**RE: Review Response to EIA Addendum, Kehoe Marine**

On Sept. 26, 2023, Jeff King a biologist from McIntosh Perry submitted a review of our EIA addendum for the conversion of a residential area to an equipment storage area at the Kehoe Marine site. In response to the review, we first provide Mr. King's review comments in italics, followed by our response.

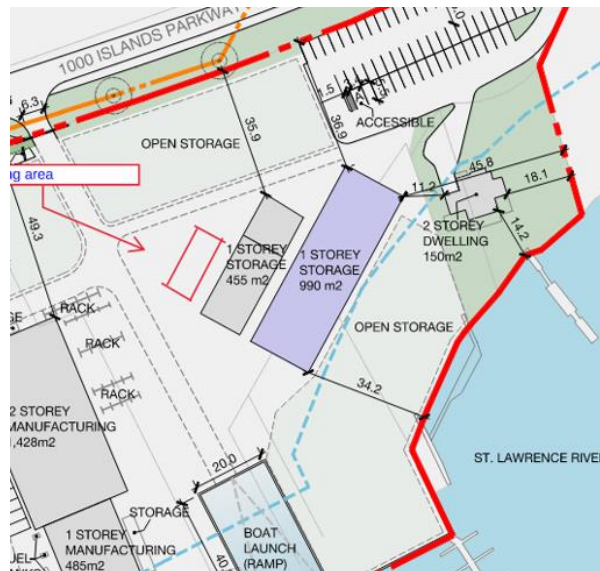
**MP Review:** *It is the understanding of the reviewer based on other information provided that the wetland boundaries were changed within the bay based on the results of the original EIA. This mapping is not found in either document or supplemental documents.*

**ES Response:** MNRF, CRCA, and the County were aware of the approved wetland boundary changes in 2022, but these were not yet made public via NHIC mapping at that time. However, the changes are now available on the MNRF’s Natural Heritage Information Center (NHIC) web site (see blue area in adjacent image). For context with this image, we have provided the approximate area where the conversion from the residential area of to a work storage is to take place. As can be seen, most of the offshore area of the conversion area is PSW, which as noted earlier, is an SAS1 ELC type.
